STAFF PAPER

Review of Riverside Public Utilities 2018 Integrated Resource Plan

April 2019 | CEC-200-2019-003

Figure 1: Riverside and Energy Commission Energy Forecasts 2017-2030 (GWh)

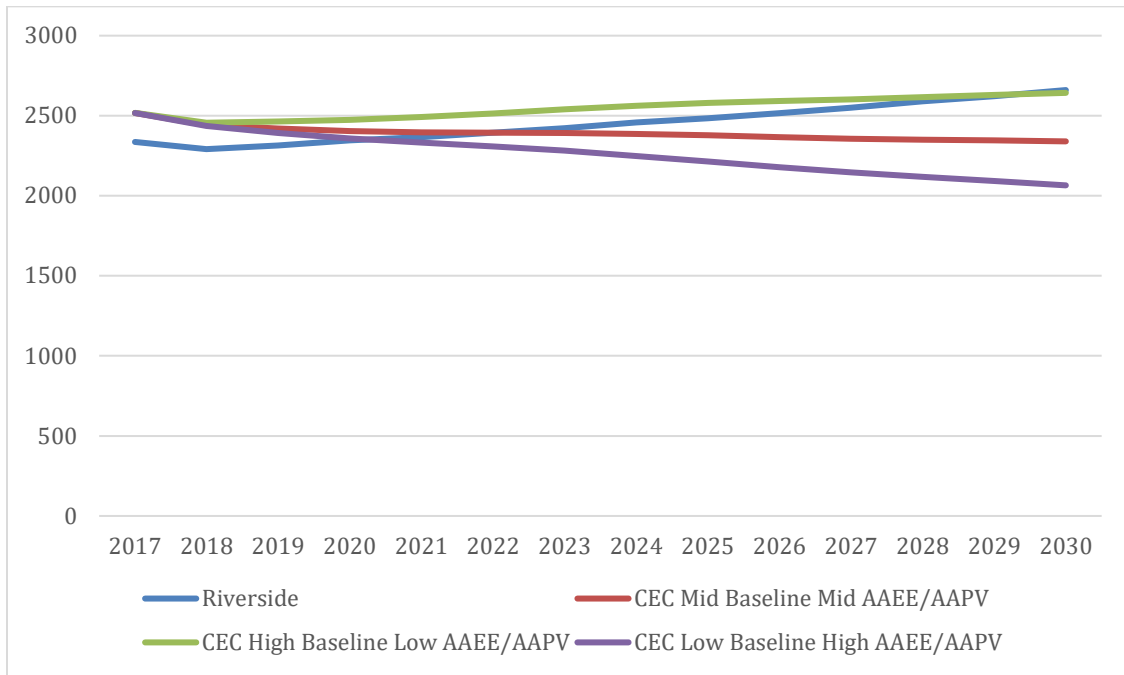
Riverside’s reported net system load for base year 2017 is 7.18 percent lower than the base year used by the Energy Commission in the demand forecast. The difference may be a result of Riverside using a different method to calculate system losses. It is also possible that Riverside used a different dataset for sales than the QFER data used by the Energy Commission because the reported retail sales in 2017 is 6.79 percent lower than the retail sales figure used by the Energy Commission. Riverside forecasts annual system load growth of 1 percent from 2017 to 2030. This is higher than 0.38 percent for the Energy Commission’s forecast in High Baseline Low AAEE/AAPV scenario. However, the differences in the forecasts are not so great as to have a significant impact of the development of a long-term resource plan. **Figure 1** shows a comparison of the Riverside’s energy forecast with the Energy Commission’s forecasts for Riverside.

Figure 2: Riverside and Energy Commission Peak Forecasts 2018-2030 (MW)

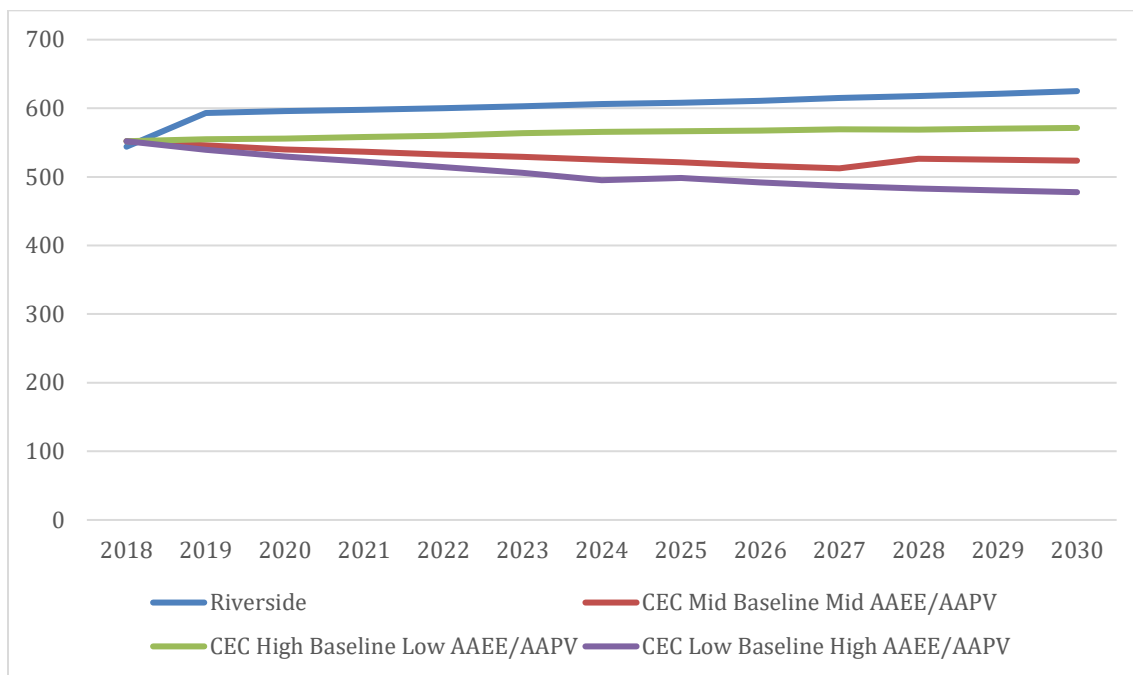
Riverside’s system peak of 2018 report in CRAT is coincident-adjusted, as determined by the Energy Commission. For 2019 and afterward, peaks are non-coincident. Riverside predicts annual system peak growth rate of 0.48 percent from 2019 to 2030. This is slightly higher than 0.26 percent for the Energy Commission’s forecast in High Baseline Low AAEE/AAPV scenario. Riverside’s forecast is reasonable for a long-term planning context. **Figure 2** shows a comparison of Riverside’s peak forecast with the Energy Commission’s peak forecast for Riverside.
